INITIAL FIRE SAFETY INSPECTION REPORT

HANDZ CLOTHING BD LTD.

RSC ID: 26542

Fire Safety Inspection Report

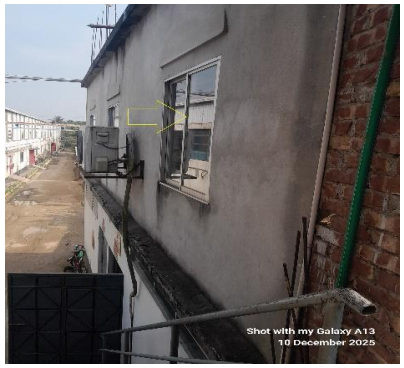
Sl No.	Category	Findings	Required Action	Remediation Time Frame
F-1	Means of Egress	The egress path along means of egress has interrupted by obstruction/storage/process **Location(s): Main Production Shed.**	Keep egress paths clear of storage/obstruction in accordance with section 6.3.9 of RSC Technical Guidelines (Standard)[1] V1.0. Means of egress shall be maintained continuously free and clear of all obstructions or impediments to full instant use in the case of fire or other emergency. No furnishings, decorations, or other objects shall obstruct exits and access to exits. Nothing shall obstruct or impede visibility to exits.	Immediately
